James A. FitzPatrick Nuclear Power Plant
Renewed Facility Operating License No. DPR-59
NRC Docket No. 50-333

Subject: Response to Request for Additional Information Associated with the License Amendment Request for Application of the Alternative Source Term for Calculating Loss-of-Coolant Accident Dose Consequences

Response to Request for Additional Information

Figure RAI-2a

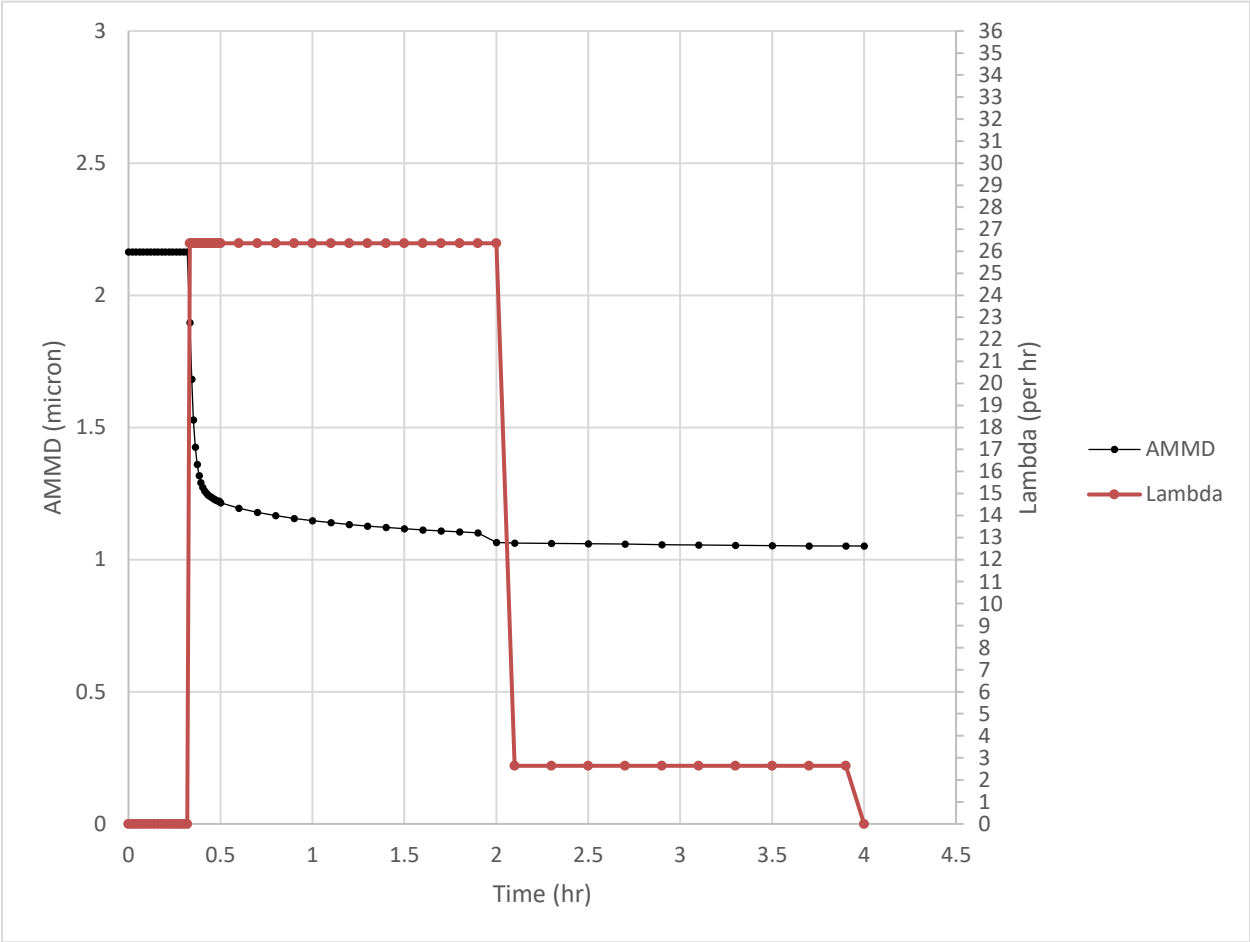
Please provide additional information describing how the gravitational settling credited in the main steam lines considers the changing aerosol characteristics (i.e., aerosol size and density distributions) due to the preferential removal of larger aerosols because of the credit assigned to containment sprays.

A simplified model was developed using first principles as identified in NUREG/CR-5966, "A Simplified Model of Aerosol Removal by Containment Sprays." Specifically, the ordinary differential equation shown on page 1 of NUREG/CR-5966 was solved to provide an analytical solution of the suspended aerosol mass in the drywell. The spray removal rate in this simplified model is the same as that identified in JAF-CALC-19-00005 Section 2.1.3 and RG 1.183, Appendix A, Section 3.3. Since sprays will remove aerosols at different rates depending on their particle size, the spray removal rate is adjusted by collection efficiency variation as provided in Figure 19 of NUREG/CR-5966. The suspended aerosol mass was solved from the beginning of the accident through the termination of the sprays at 4 hours for 20 distinct particle size groups. The mass of particles in each group is defined by the probability distribution associated with the source distribution.

The size distribution of the particles released from the fuel was assumed to be log-normal with a 2 micron Aerodynamic Mass Median Diameter (AMMD) (0.473 micron geometric mean diameter) and Geometric Standard Deviation (GSD) of 2. The aerosol mass was calculated for each group independently with no consideration of particles interacting with one another; therefore, agglomeration is not accounted for, and this conservatism will artificially and permanently lower the average particle size as large particles are removed and not replaced. The result is a much smaller gravitational settling and spray removal rate. Table RAI-2a summarizes the results of the 20-group particle size distribution in the drywell. Figure RAI-2a visually illustrates the time-dependent nature of the aerosol particle size distribution. As shown in Figure RAI-2a, the effect of the drywell spray in reducing the size of the particles is accounted for in the model.

These particle size and settling velocity distributions were then used to recalculate the aerosol removal rate using the equation provided in Appendix A of AEB-98-03 (ADAMS Accession No. ML011230531), consistent with Section 7.5.1 of JAF-CALC-19-00005. The resulting aerosol removal factors are summarized in Table RAI-2d. The aerosol removal factors including spray combined with the nodalization adjustments described in the previous section are represented by the "Base Sensitivity Case" row in Table RAI-2e.
